McMILLAN SAND FILTRATION SITE COMMUNITY CENTER & PARK DESIGN UPDATES

COMMISSION OF FINE ARTS SUBMISSION

4 MAY 2023

McMILLAN COMMUNITY CENTER LANDSCAPE DESIGN UPDATE

Figure 4: McMillan Memorial Fountain updated location enlarged plan

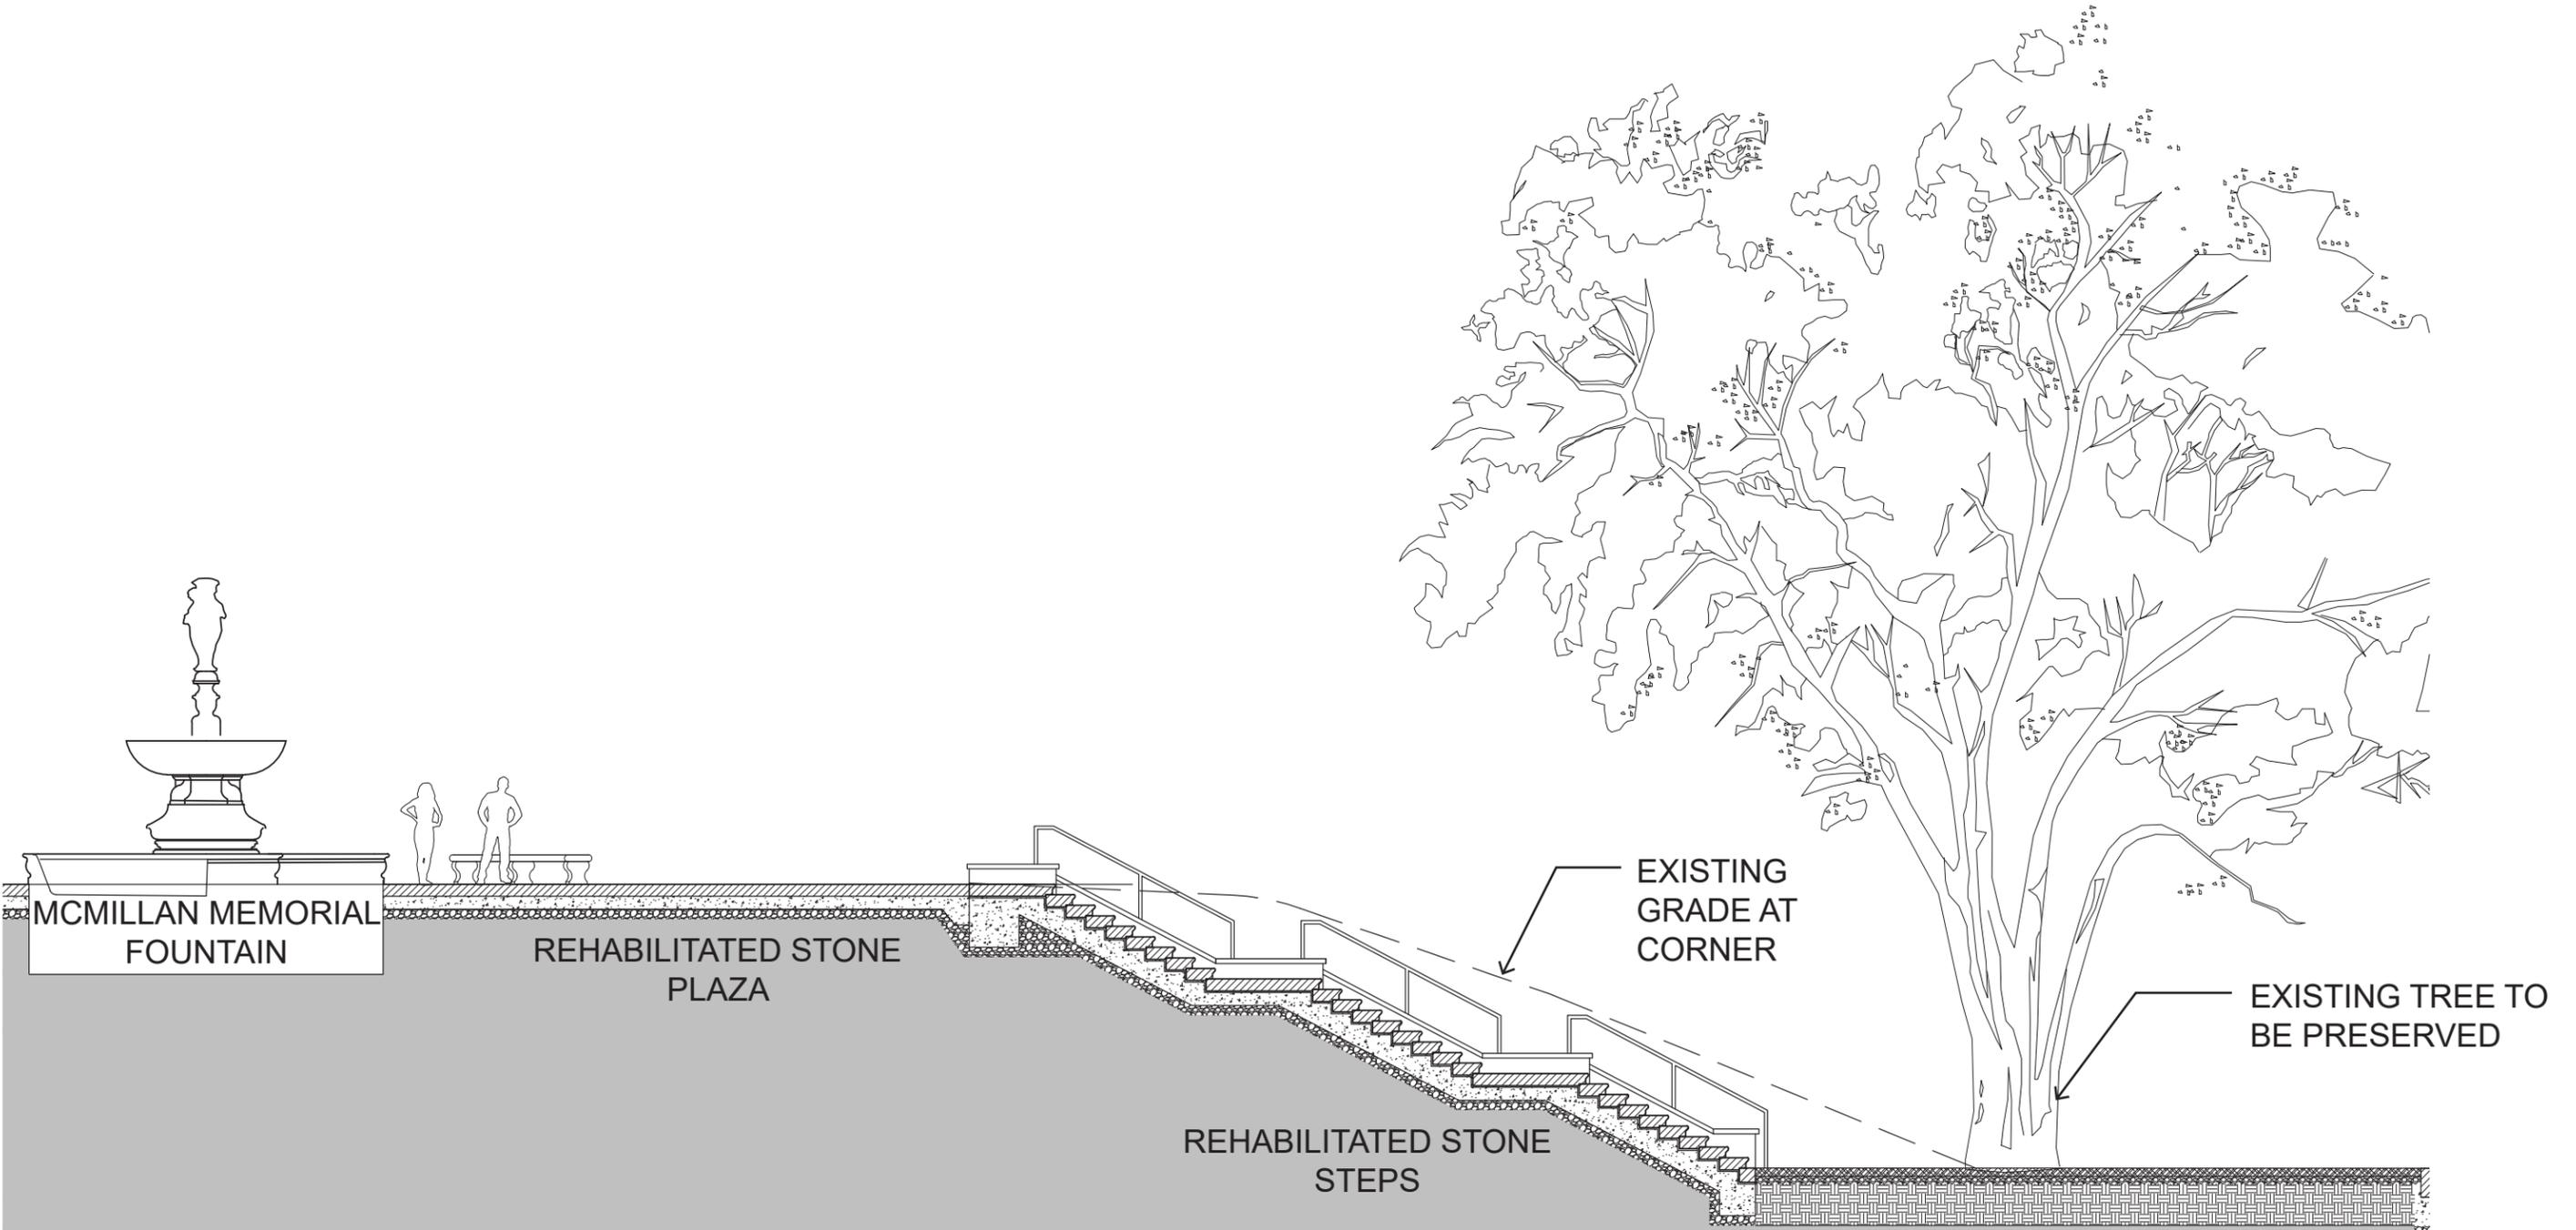
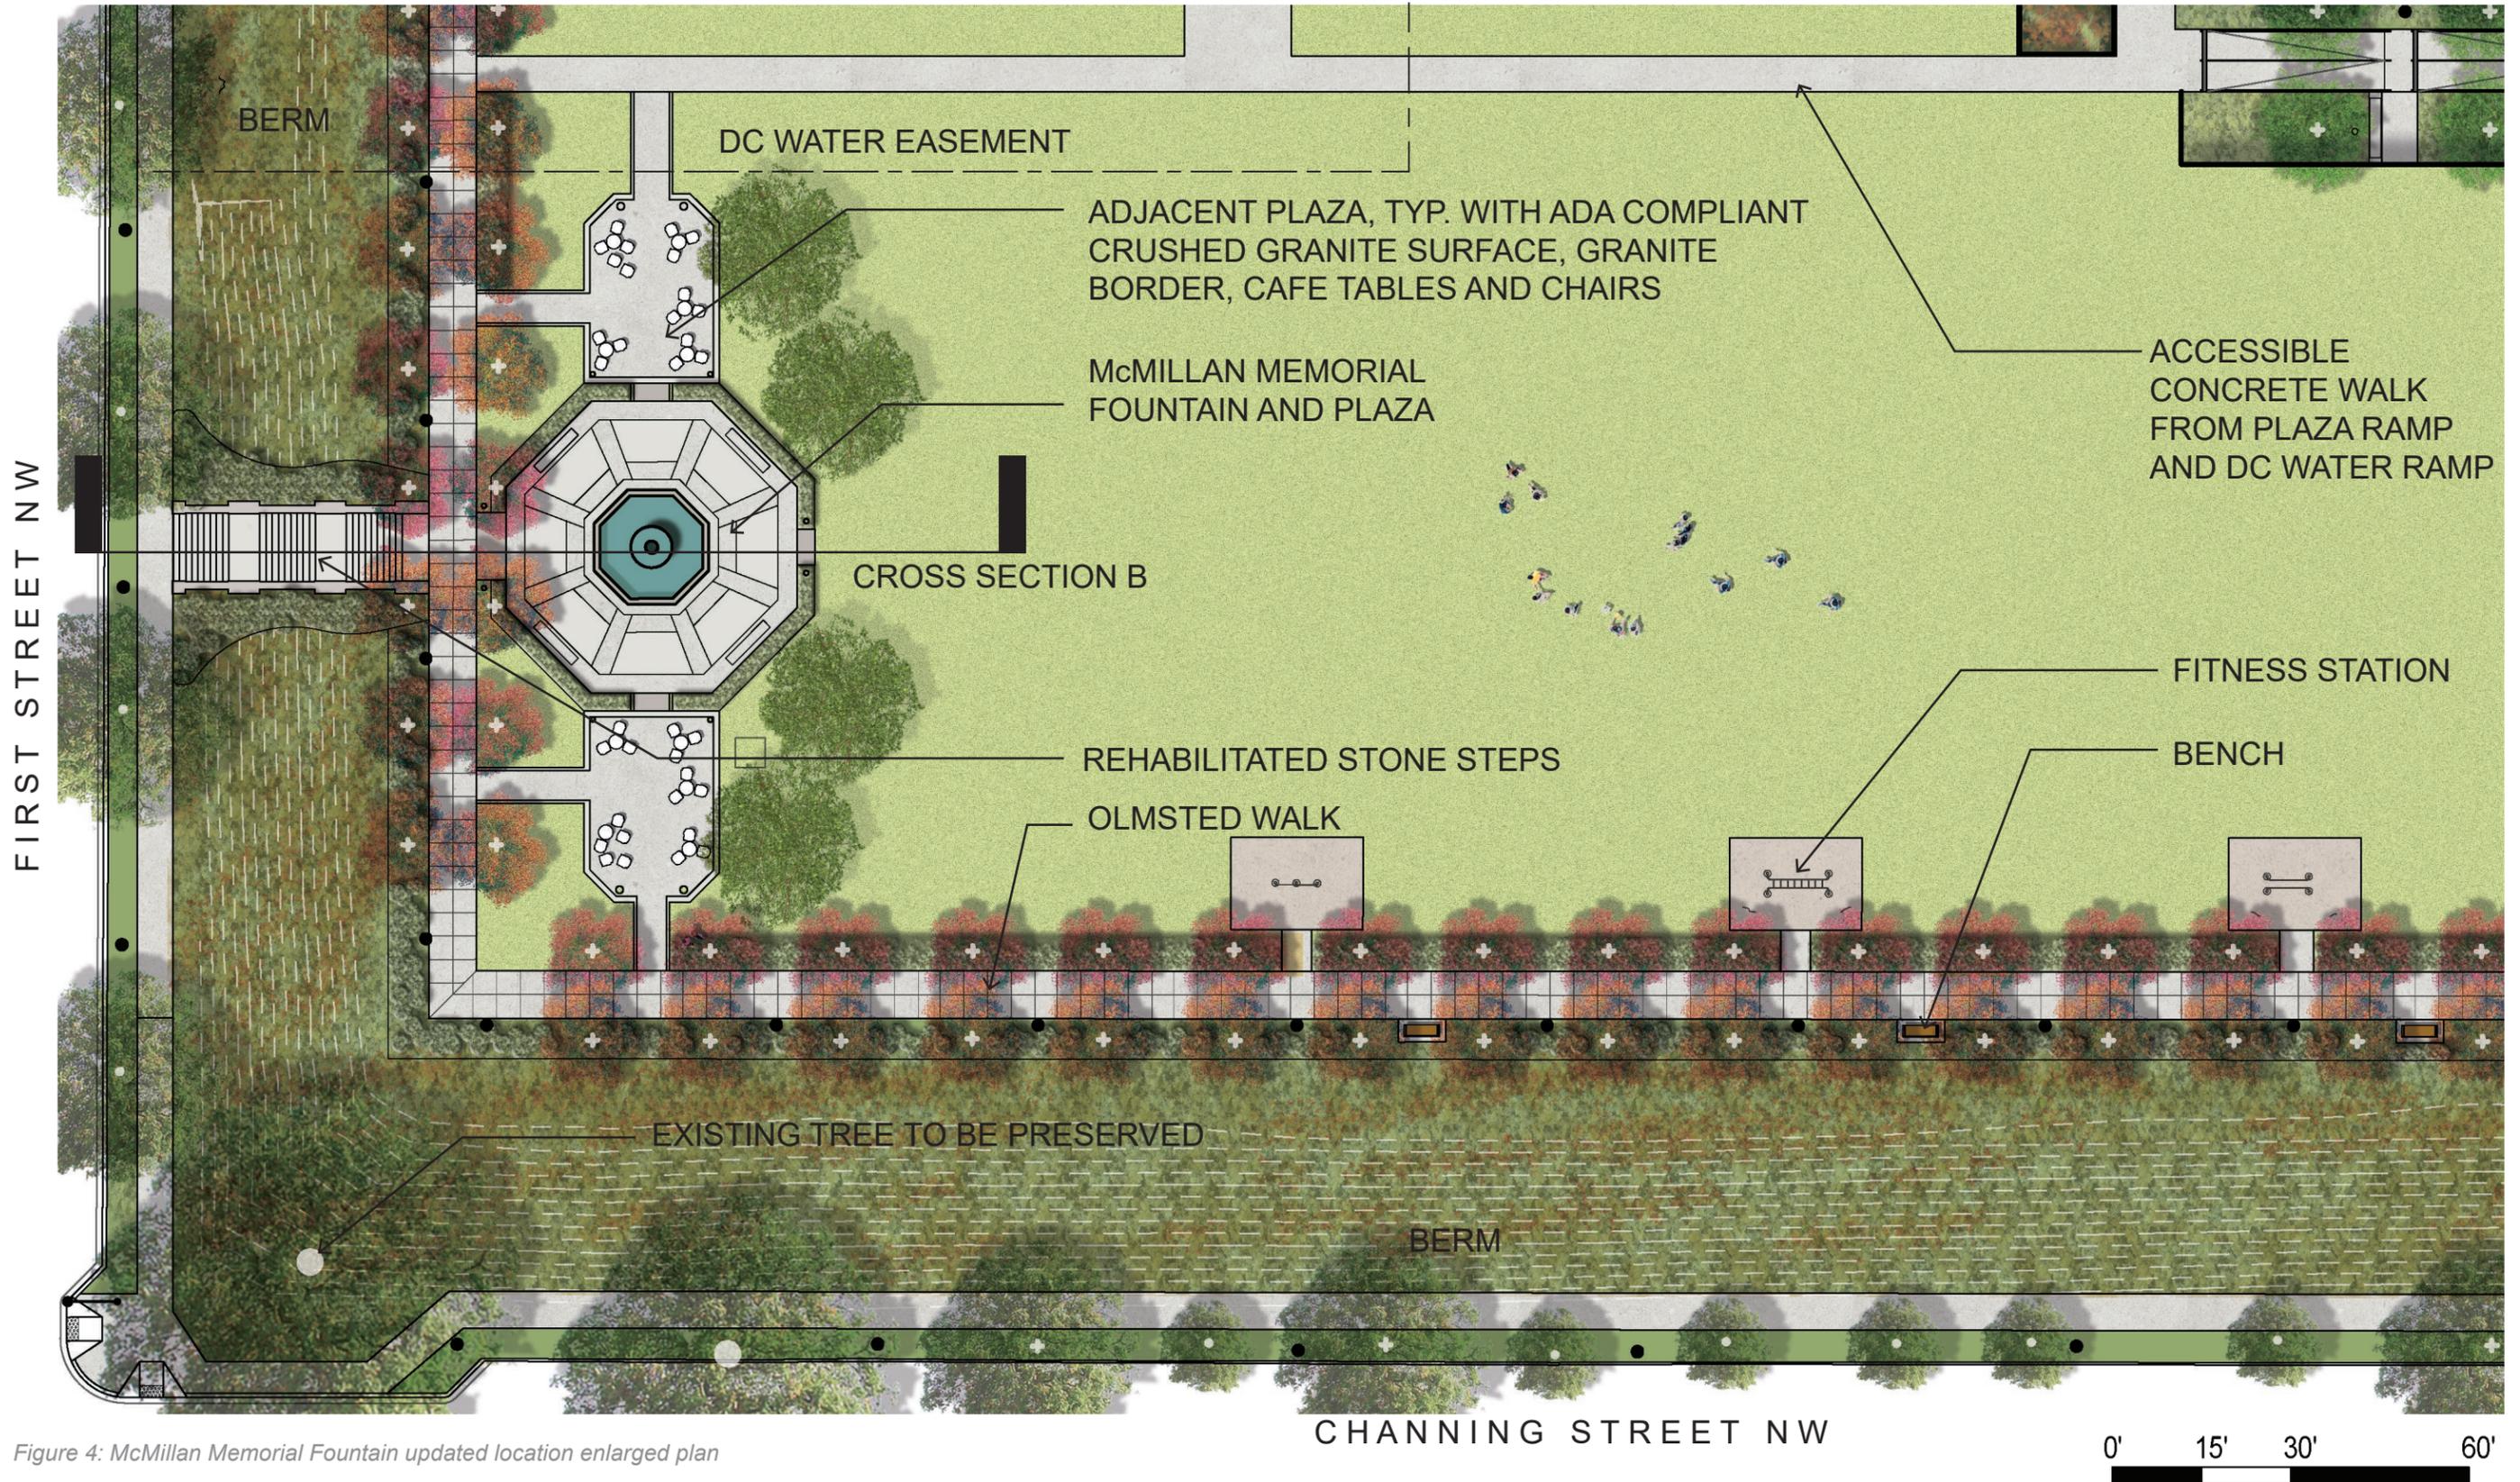
The McMillan Memorial Fountain, its stone plaza, and the original stone steps are proposed to be installed in a new location, just north of the southwest corner of the site.

When presented to the Commission of Fine Arts in June 2020, the fountain and plaza were shown at the southwest corner, with the stairs descending to the intersection of Channing and First Streets. This design was based upon recommendations made in the 2016 McMillan Sand Filtration Site Historic Preservation Plan by EHT Tracerics. That document stated (page 87) that the "large existing tree at the corner of First and Channing is not part of the historic planting of the Site, and should be removed." Because the tree has a circumference of greater than 100 inches, it is designated a "heritage tree." As such, the Owner has elected to preserve the tree rather than remove it. Engineering solutions to adapt the stone steps so that they could bridge over the critical root zone of the heritage tree were unsatisfactory to ensure that the tree would survive construction.

As a result, the design team has developed an alternative location for the McMillan Memorial Fountain and its associated stone steps and plaza paving. This revision relocates the fountain and its 2,000 square foot stone plaza forty feet north of the location shown in the 2020 submission to the Commission of Fine Arts. It reorients the rehabilitated stairs to descend from the fountain to First Street perpendicular to the north-south face of the westernmost berm rather than on the diagonal to First and Channing Streets. This revision restores the original alignment of the McMillan Memorial Steps along the face of a berm rather than at the intersection of two perpendicular berms. The relocation also changes the relationship of the

fountain to the Olmsted Walk: When shown to the Commission of Fine Arts in June 2020, circulation along the Olmsted Walk at the southwest former of the site passed through the fountain plaza via two 45-degree bends in the paved walk. By moving the plaza north of the southwest corner, the Olmsted Walk is now completely separate from the fountain plaza. A five-foot length of stone paving will serve as the transition from the Olmsted Walk to the fountain plaza. This offset allows the plaza to be more quiet and contemplative than the former condition where the Walk passed through the space.

The design has been further updated to provide two flanking plazas, one to the north and one to the south of the rehabilitated plaza. These will be smaller than the fountain plaza, and surfaced with compacted crushed granite edged with flush granite bands. Movable tables and chairs will be provided to encourage flexible use of these two seating areas.
